BAR Meeting
February 18, 2009

ISSUE: New Construction
APPLICANT: Sophie Development LLC
LOCATION: 714 Wythe Street
ZONE: OC/Office Commercial

BAR CASE #2008-0193

Figure 5. Proposed front (north) elevation.

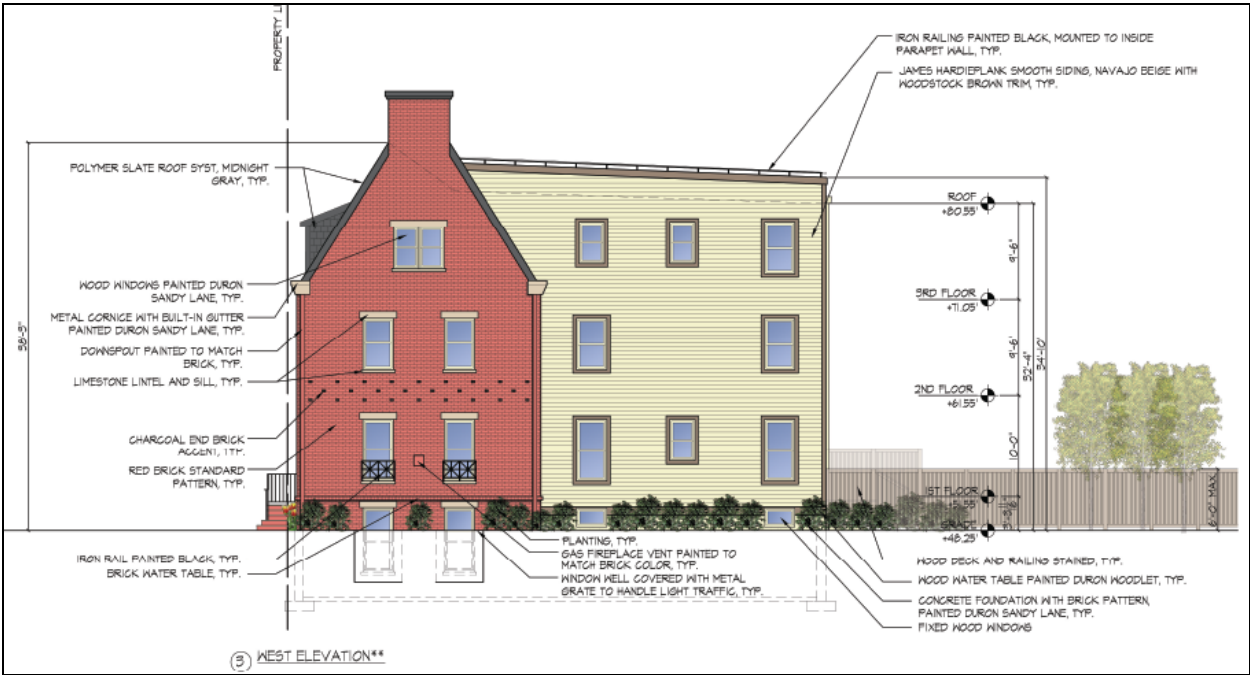
1. That the Applicant revise the design of the front elevation to bring the front doors forward.
2. That the Applicant restudy the tower portion of the rear exterior.
3. That the Applicant restudy the side elevations to bring down the cornice line of the roof from the third floor to the second floor.

The front (north) elevation is two stories plus an attic story with shed dormers. This elevation is symmetrical with a six-bay pattern, three bays for each townhouse. In the current submission the paired entry doors are brought forward, with only a slight recess of 1' from the front building wall. The revised stairs are no longer recessed and instead the front stoop is a split, double stair which projects 3' into the public right-of-way. The stoop will be brick, with treads and landing of limestone, with a simple black wrought iron railing. The opening below the stoop will house meters and will be screened with metal access doors that will match the decorative railing at the windows on the first level. On the previous submission, the applicant proposed a central double entryway with recessed flagstone stairs leading to side-by-side entry doors on the front elevation with a brick foundation with a brick water table. The original submission had dark gray ashlar blocks proposed for the foundation.

Staff finds that the style, massing, height and fenestration of the front elevation are generally appropriate. The three-story building reads as a two-story-plus-attic building and reflects the general architectural patterns found throughout the historic district.

In the current scheme, Staff finds that the front entrance has been successfully revised by bringing the doors forward and creating a double stair split stoop encroaching onto the sidewalk. Staff finds that this is most compatible with traditional entryways and stoops. The materials proposed are consistent and compatible with materials for the rest of the project. In addition, the revised entrance at the front building plane articulates the building as two distinct townhouses.

The first story windows are taller than the second story windows, reflecting traditional fenestration patterns. The *Design Guidelines* note the following about dormers: “dormer sashes should be operable and should be the same type as the other window sashes on the structure,” “shed dormers are strongly discouraged,” and “dormers should match the existing proportions of the building and the windows.” Staff has informed the applicant that shed dormers on prominent elevations are generally not approved by the Board. The applicant has studied various dormer configurations and styles and concluded that the shed is most appropriate for this design as it minimizes height and prominence on the third story. The applicant provided studies of various dormer types and configurations to BAR Staff and the City Architect. While the *Guidelines* discourage shed dormers, it is important to note that the *Guidelines* encourage reviewing each design on a case-by-case basis and to acknowledge that the *Guidelines* are general directions rather than strict prescriptives. Staff also notes that there are some examples of front elevation dormers on historic buildings within the district. As a result, Staff finds that the proposed shed dormers, smaller and more refined than those originally proposed, are the most supportable design solution for this project.

application of a small amount of ornament or detailing. Staff does not object to the central entrance and finds that the revised front entryway and stoop coherently expresses the differentiation of the two townhouse units. Staff finds that the use of a recessed element at the center of the limestone lintel, a vertical line of recessed brick at the second story, and a break in the cornice at the center property line successfully differentiates the building as two townhouses.

- Bringing forward the front doors and eliminating the deep recessed entryway
- Revising the front stoop to a double stair encroaching 3' into the public right-of-way

Staff finds that the latest revisions found in this submission, are consistent with the *Design Guidelines* and the direction given by the Board at the previous hearing. Specifically, bringing the front entrance forward and creating a double stair stoop, as well as eliminating the rear "tower" element, have been great improvements to the project.

Figure 6. Proposed side (east and west) elevations.

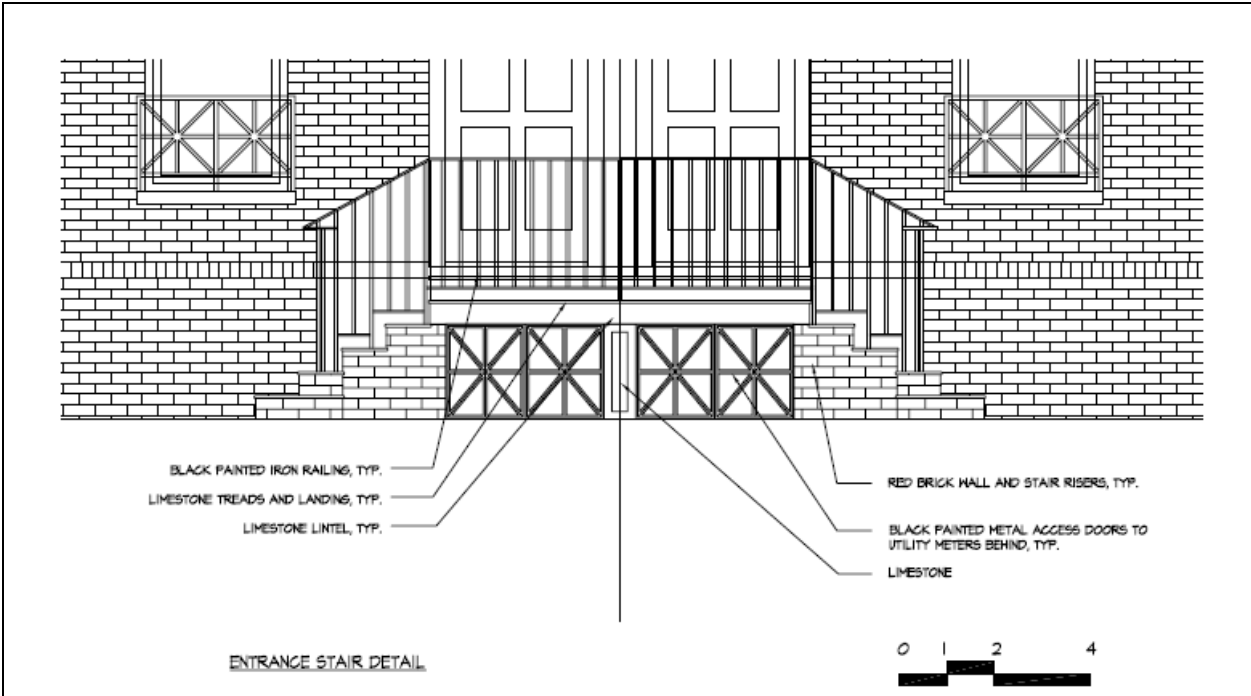
The side (east and west) elevations continue the form and materials found on the front elevation for approximately 24' (originally 20'). This front third of the side elevations wrap around the brick from the front elevation and feature end wall chimneys. The basement level will have two single-light windows and window wells with metal grates. The first and second stories will have two one-over-one, double-hung, double-glazed wood windows with limestone sills and lintels (in the original submission the second-story windows were ganged). The third story will have

The side elevations are both bounded by public alleys, making the side elevations highly visible. Staff finds that the transition on the side elevations from the brick portion to the frame portion is appropriate. As houses evolve and change over time, the introduction of a new building material, such as siding on a rear frame addition to a main block of brick, often occurs. However, what generally makes such different materials and forms successful is that the rear portion is lower than the main block. The applicant previously revised the design to extend the depth of the brick portion, thereby reducing some of the original bulk of the frame portion. The current design no longer has the rear projecting “tower” element which Staff finds to be an improvement over the previous schemes.

Upon review of the original submission, Staff was concerned that the proposed fenestration on the frame portion was disjointed from the front elevation and generally inappropriate. The applicant previously revised the fenestration of the side elevation to be more historically appropriate through the use of single windows and a reduction in size of the third story windows.

Staff has no objection to the use of porous grass pavers running along the side elevations. Staff finds that the use of foundation plantings is more appropriate on the side elevations than the plastic bollards originally proposed.
